# TECHNICAL SERVICE BULLETIN

<b>ISSUE DATE:</b>	4/26/2021
<b>SERVICE BULLETIN SUBJECT:</b>	Duopower Belly Pan Fastener Retrofit
<b>VINs or MODELS AFFECTED:</b>	Service Specified Buses
<b>COMPLETE BY:</b>	Next Service Opportunity
<b>SERVICE BULLETIN #:</b>	SC-21-60
<b>LABOR OPERATION CODE:</b>	UU43Z

## DUOPOWER BELLY PAN FASTENER RETROFIT

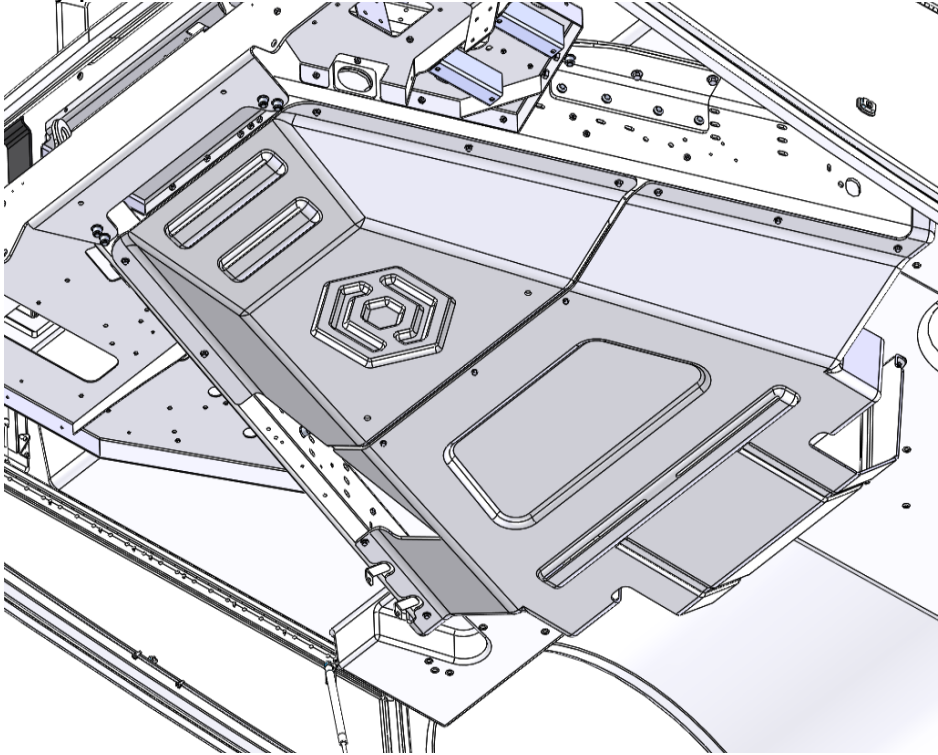
The procedure replaces the belly pan fasteners with improved fasteners for better weather resistance.

- 057554 SERVICE KIT, DUOPOWER BELLYPAN FASTENERS (Consisting of)
  - 017655-005 BOLT,HEX,FLG,STL,1000HSS,CLASS 8.8,M6-1.0X25X25 15 EA

- 018218 WASHER,LARGE FLAT,STL,1000HSS,CLASS 10.9, M6 15 EA

3. Using a 10mm Ratchet/Socket, remove each of the original fasteners one at a time.
4. Using a 10mm Ratchet/Socket, replace the removed fastener with a new M6 Bolt (017655-005) and Washer (018218).
5. Using a Calibrated Torque Wrench with a 10mm Socket, **torque the fastener to 80 inch pounds.**
6. Repeat the process to replace and torque all the belly pan Bolts (017655-005) and Washers (018218).
7. Safely lower the bus.
8. Remove the Lockout/Tagout devices and power on the bus.
